SERVICE BULLETIN

APPLICABILITY: 2022MY Outback Wilderness NUMBER:

DATE: 08/13/21 Trailer Hitch Fascia Panel / Lack of Adhesion

Bulletin Number: 12-224-21; Date: 08/13/21 Page 1 of 4

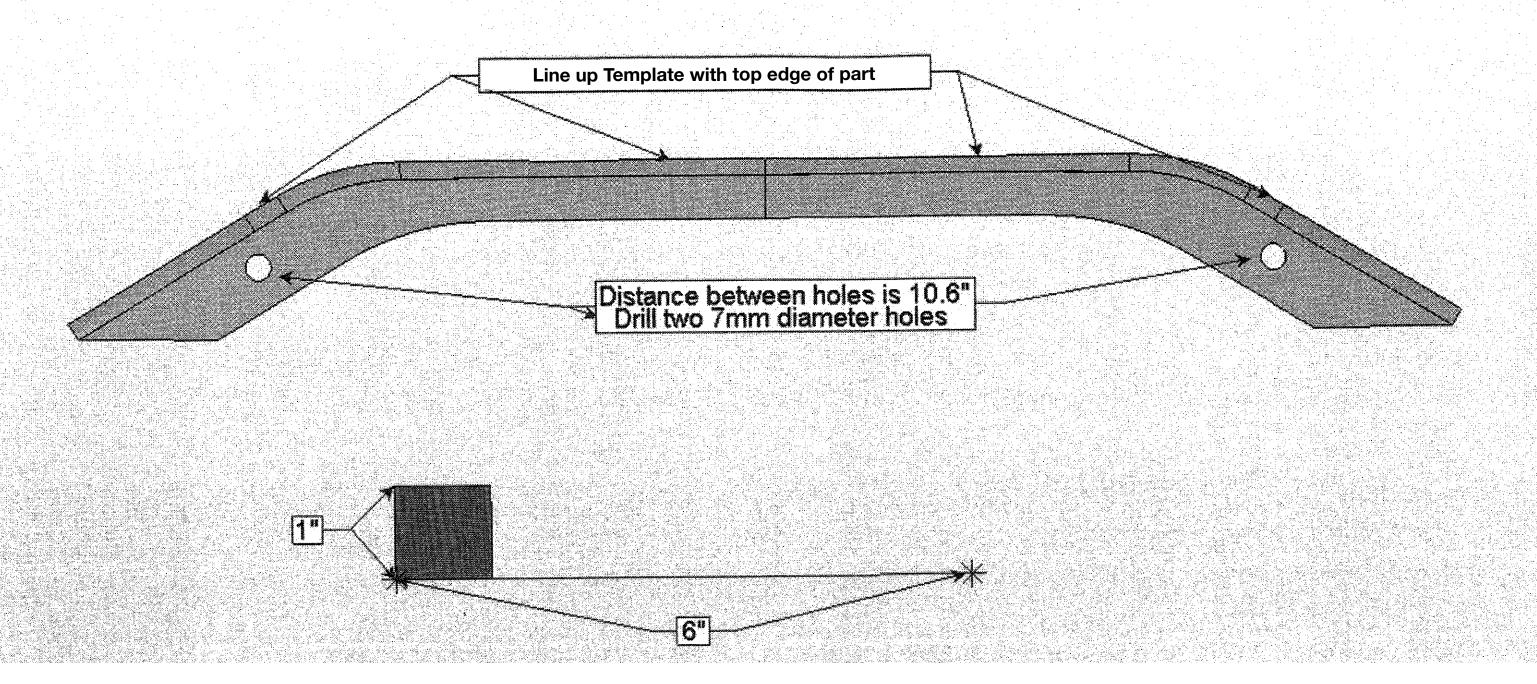
LACK OF ADHESION AREAS

- STEP 2) Print out the template supplied at the end of this document. It is **CRITICAL** that the template is printed in "**Actual Size**" and on legal paper. The template size can be confirmed with a ruler. **ALWAYS** confirm your printer properties when printing templates.
- STEP 3) Attach the template to the fascia using masking tape. There are alignment marks included in the printable template.
- STEP 4) Prepare a 7mm drill bit with a stopper or "wrapped tape" set to 1/2 inch to maintain drill depth. It is IMPORTANT to verify the Reverse Automatic Braking (RAB) harness is clear of the selected drilling areas. CAREFULLY drill two 7mm diameter holes into the fascia and bumper cover using the provided template. Always double-check the alignment before drilling.

STEP 5) Install the clips #909140062 into the drilled holes. Confirm the fascia maintains minimal gaps and is secured properly to the bumper cover as shown below to complete the procedure.
